Technical Service Bulletin

Topic	91 Driver assist systems: failure of various driver assist systems, DTC "B201000: No basic setting" in DA 810B
Market area	United States 444 Volkswagen of America, Inc. (6444)
Brand	Audi
Transaction No.	2079136/1
Level	EH
Status	Released for publishing
Release date	Sep 5, 2025

Audi Q5

Figure 1. Incorrect cable routing (left in image) and correct cable routing (right in image) of bumper wiring harness

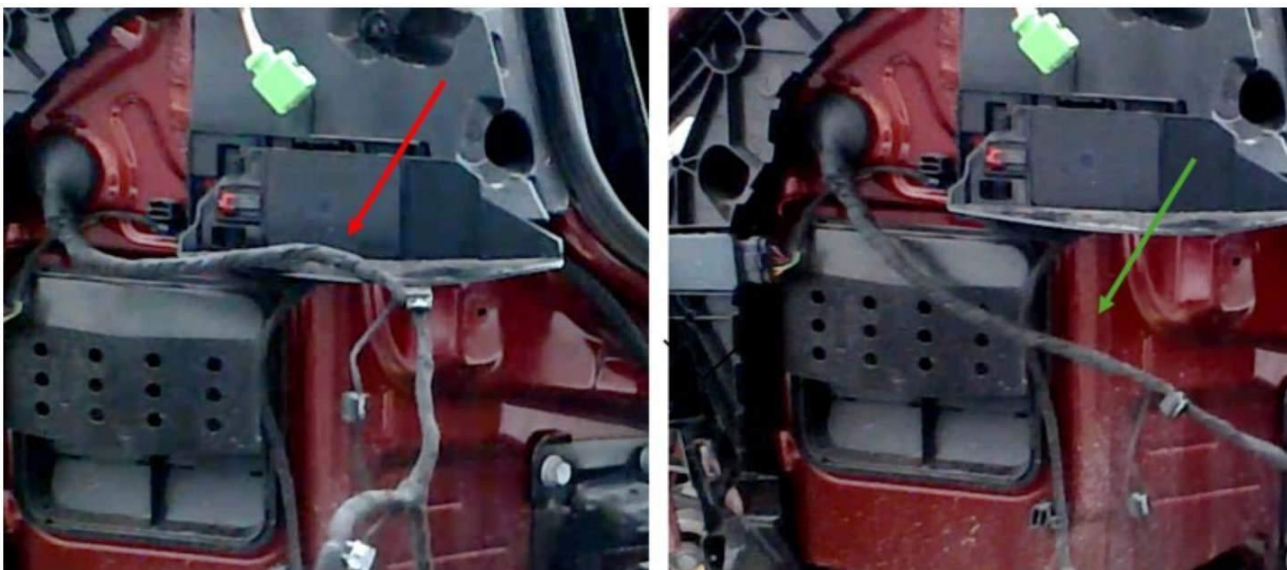
Potential incorrect cable routing of bumper wiring harness – causes harness to obstruct field of view of the sensor of lane change assist control unit -J770-. Please refer to the following images and the video provided in the TSB.

Figure 1 (left) shows incorrect cable routing of bumper wiring harness in field of view of sensor of lane change assist control unit -J770-

Figure 1 (right) shows the correct routing of the bumper wiring harness below the field of view of sensor.

Incorrect cable routing in the field of view of the sensor may be the cause of the event memory entry "**B201000: No basic setting (symptom number 1301)**".

Install the rear bumper cover and make sure that the bumper wiring harness is routed below lane change assist control unit 2 J770 (see Figure 1, right).

Figure 4. Left – previous cable routing. Right – new cable routing with cable tie with terminal socket WHT 001 999.

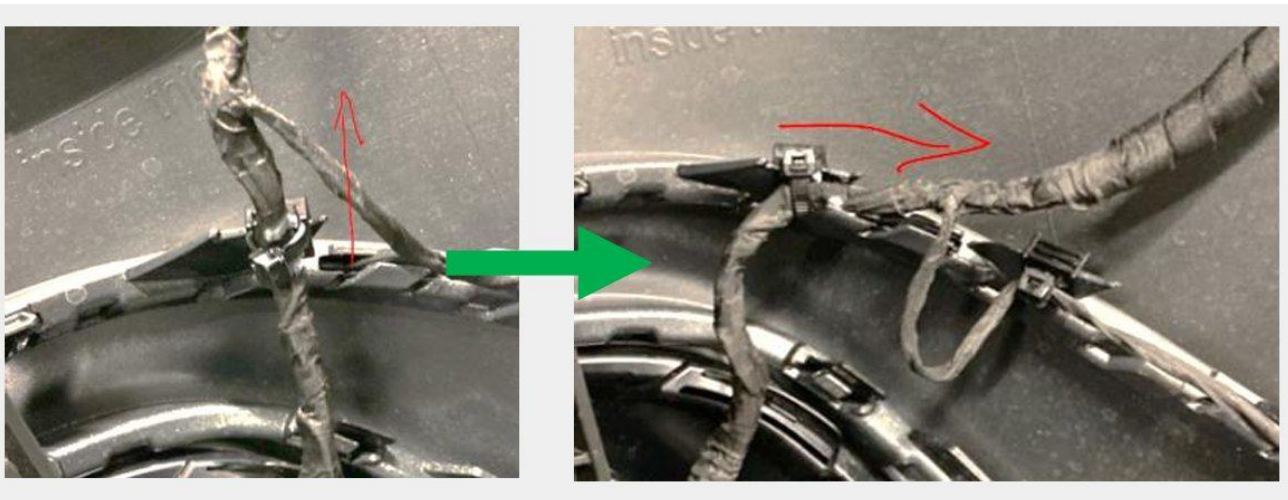
Remove the rear bumper cover. Remove the wrong cable tie with terminal socket at the position shown (see Figure 3) and affix cable tie with terminal socket WHT 001 999 in its place.

The new cable tie enables the cable to be rotated 90° and makes it easier to route the cable (see Figure 4).
